35/13-040 5 West Melrose Street
Chevy Chase Historic District

SUBJECT: Historic Area Work Permit # 343357

HISTORIC PRESERVATION COMMISSION STAFF REPORT

PROPOSAL: Driveway, timber wall, and front porch steps material replacement; Fence extension

B
ELEVATION OF HOUSE WITH STAIRS HOVED - ELEVATION B
SCALE 1/8"=1'-0"

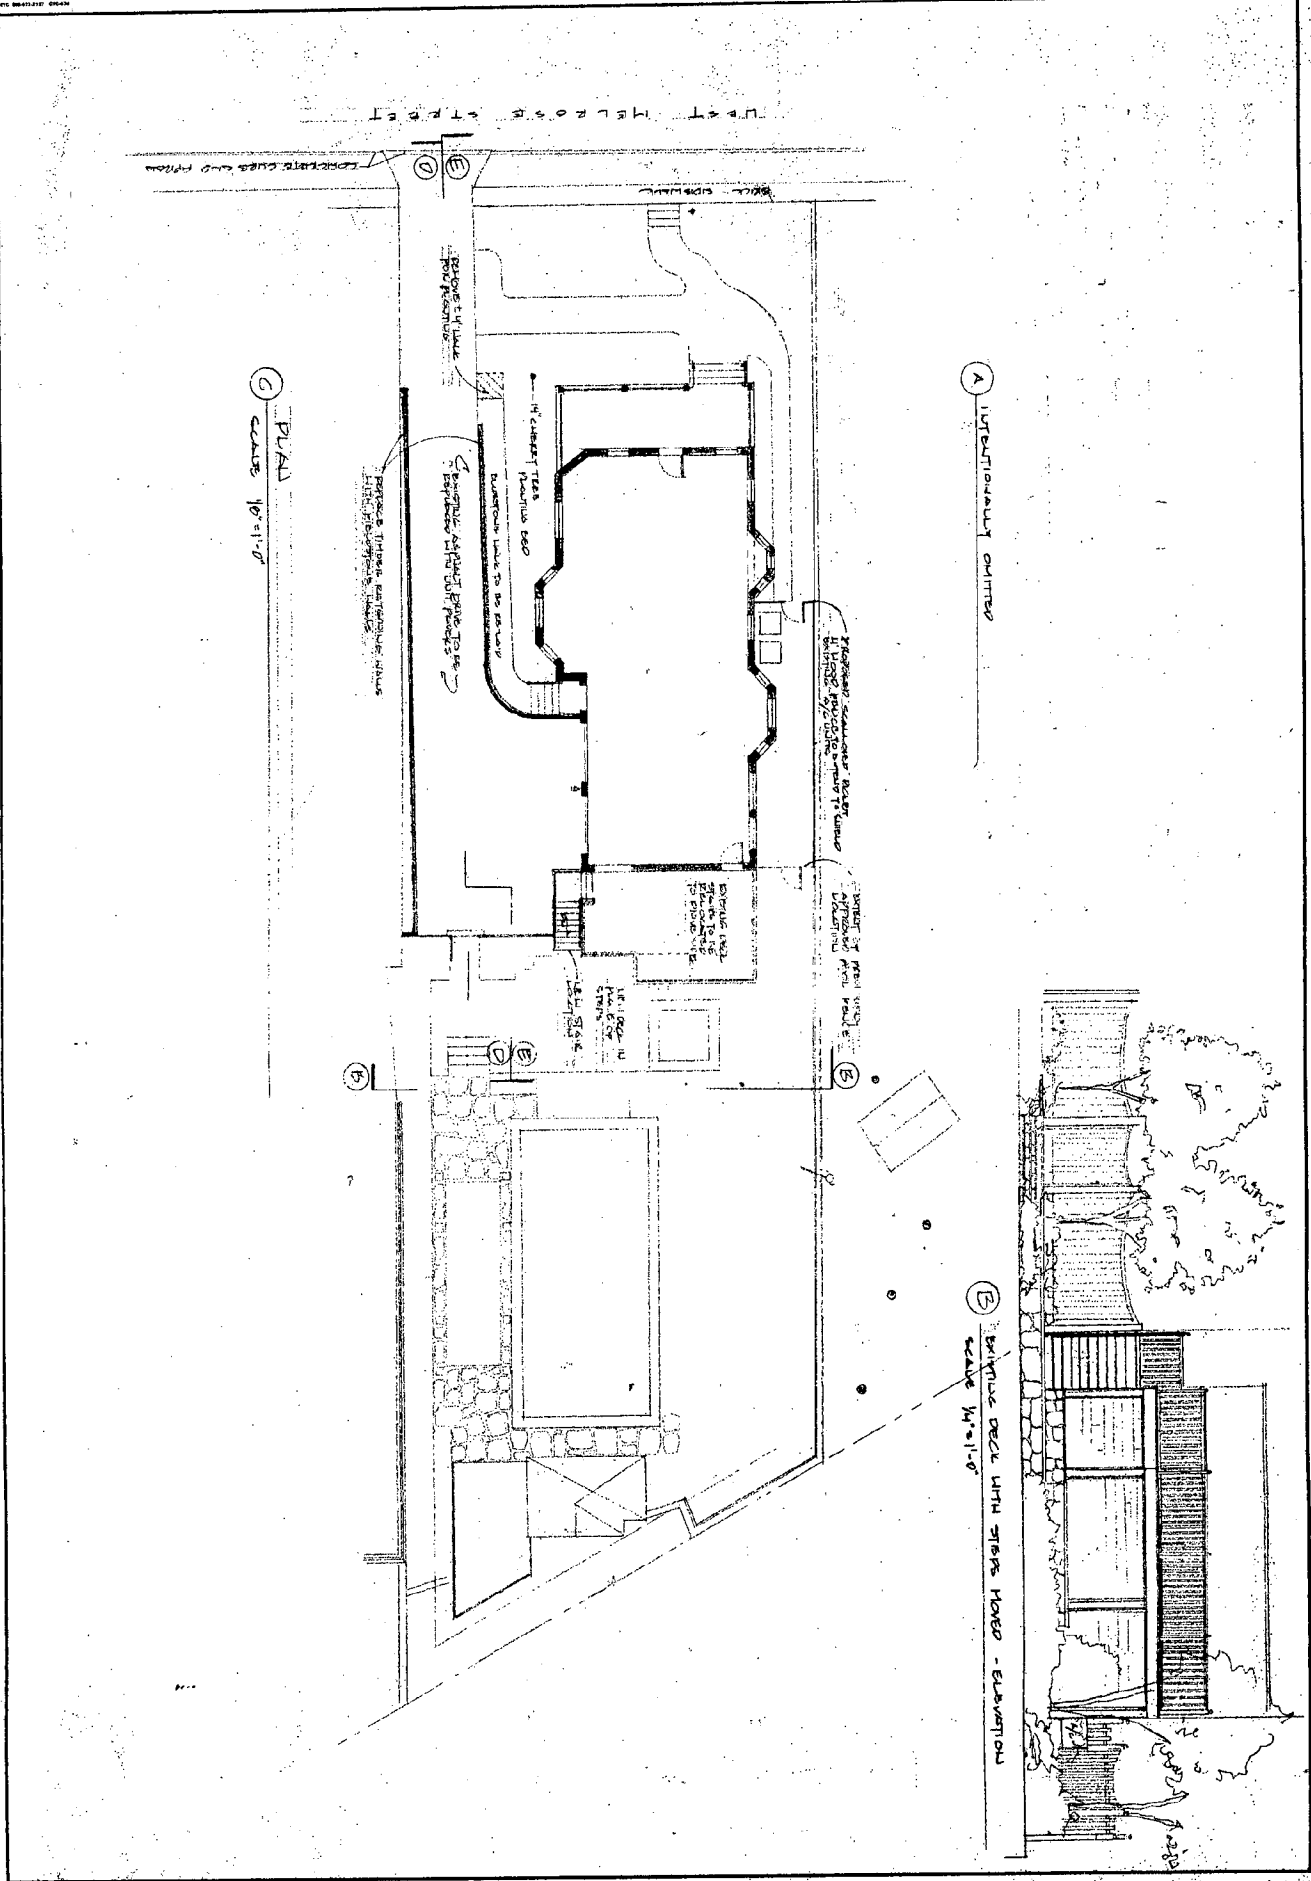
The applicants have deleted the front porch step alterations from their current HAWP application to be reviewed by the Commission on the May 26, 2004 Agenda. The applicants do not object to the rest of the staff conditions as shown on the staff report.

The attached drawings illustrate the deletion of this item.

PLAN

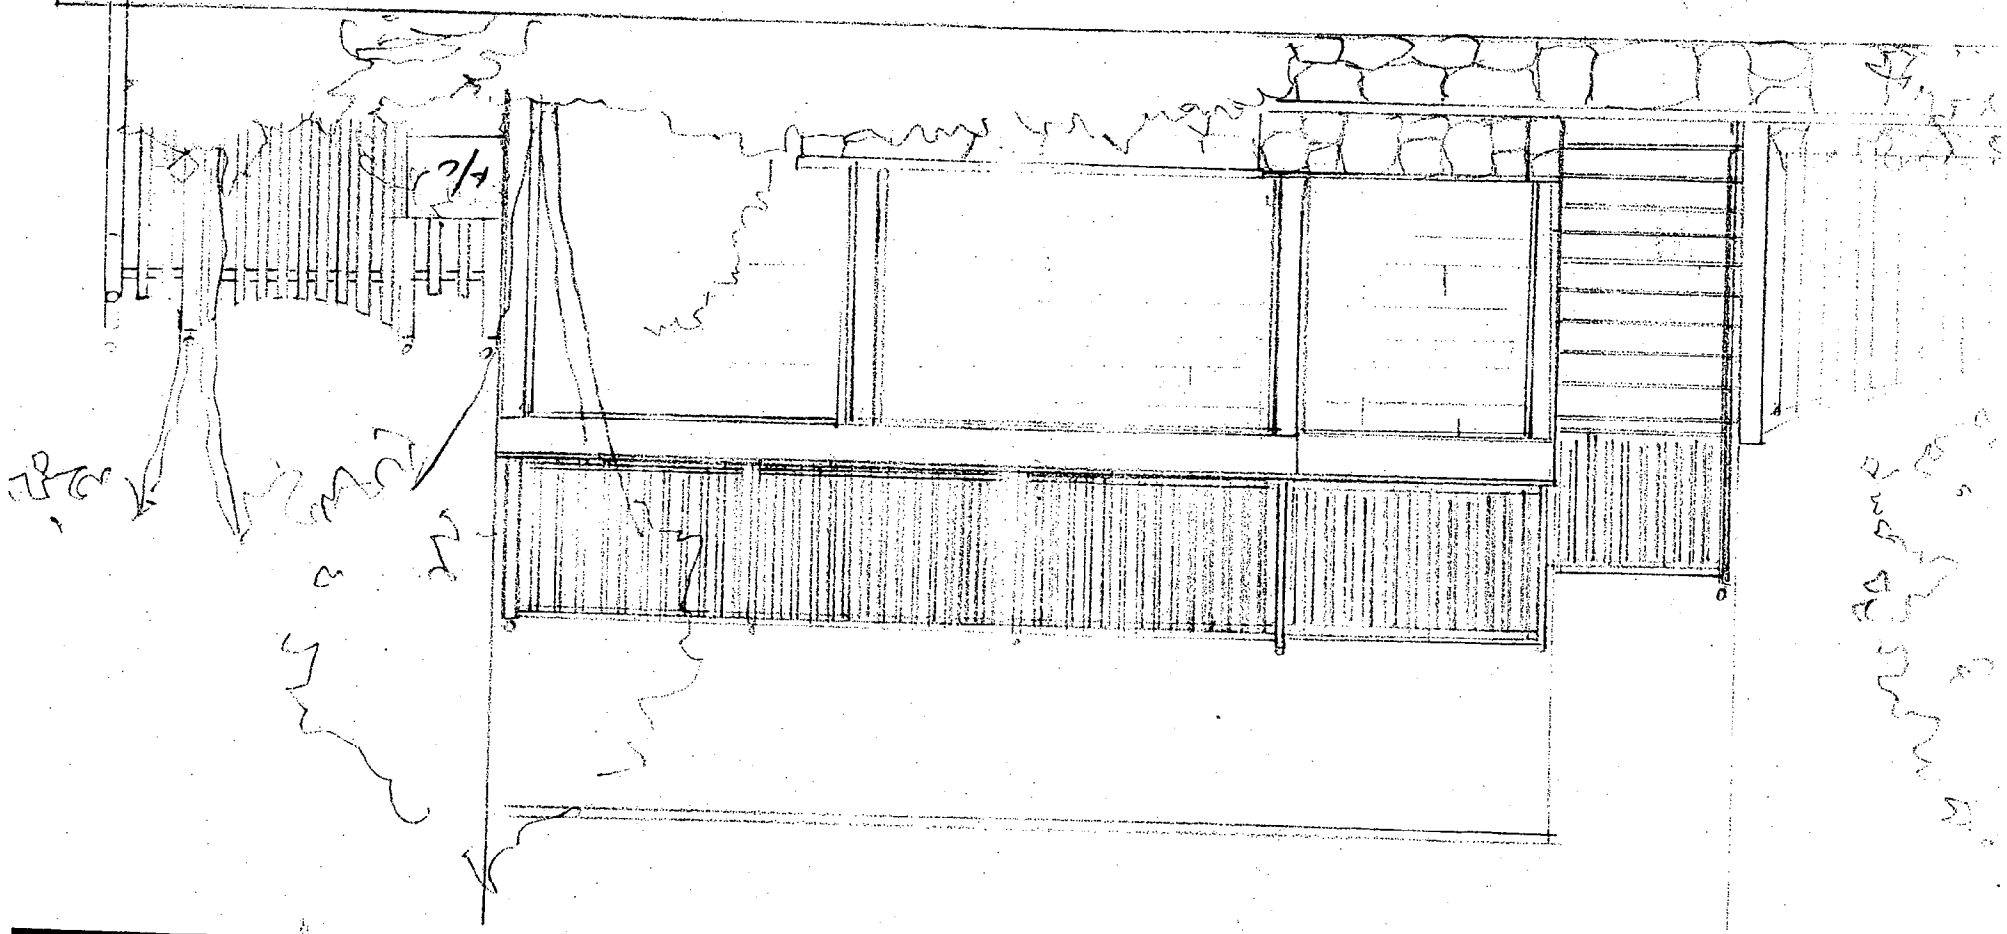
The driveway's size and configuration will not be changed as a result of the material replacement.

Proposed fence installation along the west elevation will not exceed 4' in height.

The original front porch's materials will not be changed.

It has been the Commission's policy to approve fences in the exceeding 4' in height to be located in the rear yard, not exceeding beyond the rear elevation of the house, as such, the proposed fence to shield the A/C units should not exceed 4' in height, as it is forward of the rear elevation.

Secondly, the proposed alteration of the porch steps and column bases concerns staff. This proposed change of an original feature compromises the original design intent and as such reduces its integrity. Staff strongly objects to this change and is recommending that this aspect of the proposal be omitted.
